REVISED RESPONSE TO REQUEST FOR ADDITIONAL INFORMATION

APR1400 Design Certification

Docket No. 52-046

RAI No.: 189-8057
SRP Section: 16 – Technical Specifications
Application Section: 16.3.1 Reactivity Control Systems
Date of RAI Issue: 09/01/2015

3.1.4 Moderator Temperature Coefficient (MTC)

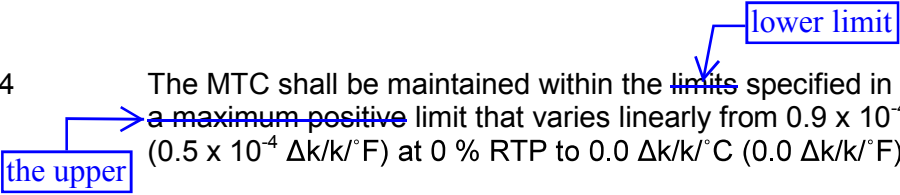
Clarify an omission from the STS in Surveillance Requirement (SR) 3.1.4.1.

The text in the STS reads “Verify MTC is within the upper limit specified in the COLR.” The APR1400 text reads “Verify MTC is within the upper limit.” The phrase “specified in the COLR” is commonly used in the APR1400 text when referring to limits, which aligns the text with the STS.

The deviation report, APR1400-K-O-NR-14001-NP, states that “The actual value of the MTC is dependent on core characteristics such as fuel loading and reactor core soluble boron concentrations. Since positive MTC limits assumed in the safety analysis are not to be challenged or must be met using burnable absorbers for both initial and the reload cores, thus, those are not classified as COLR item in APR1400.” However, the LCO statement and the NOTE for SR 3.1.4.2 both refer to COLR limits.

As described in the deviation report, the positive MTC limit is not classified as a COLR item for the APR1400, but rather the maximum positive MTC limit is given as a linear function of rated thermal power as specified in the LCO statement. Thus, the COLR is mentioned for the negative or lower MTC limit specification (3.1.4.2) only. ‘The limits’ in the LCO statement refers to the negative MTC limit in the COLR, while the positive MTC limit is specified in the LCO statement.

The Technical Specifications LCO 3.1.4 and SR 3.1.4.1 will be revised for consistency and clarity.

LCO 3.1.4 The MTC shall be maintained within the limits specified in the COLR, and a maximum positive limit that varies linearly from $0.9 \times 10^{-4} \Delta k/k/^{\circ}C$ ($0.5 \times 10^{-4} \Delta k/k/^{\circ}F$) at 0 % RTP to $0.0 \Delta k/k/^{\circ}C$ ($0.0 \Delta k/k/^{\circ}F$) at 100 % RTP.

SURVEILLANCE		FREQUENCY
SR 3.1.4.1	<p>Verify MTC is within the upper limit.</p> <p><u>specified in LCO 3.1.4</u> </p>	Prior to entering MODE 1 after each fuel loading
SR 3.1.4.2	<p>----- NOTE -----</p> <p>If the MTC is more negative than the COLR limit when extrapolated to the end of cycle, SR 3.1.4.2 may be repeated. Shutdown must occur prior to exceeding the minimum allowable boron concentration at which MTC is projected to exceed the lower limit.</p> <p>-----</p> <p>Verify MTC is within the lower limit specified in the COLR.</p>	<p>Each fuel cycle within 7 effective full power days (EFPD) of reaching 40 EFPD core burnup</p> <p><u>AND</u></p> <p>Each fuel cycle within 7 EFPD of reaching 2/3 of expected core burnup</p>
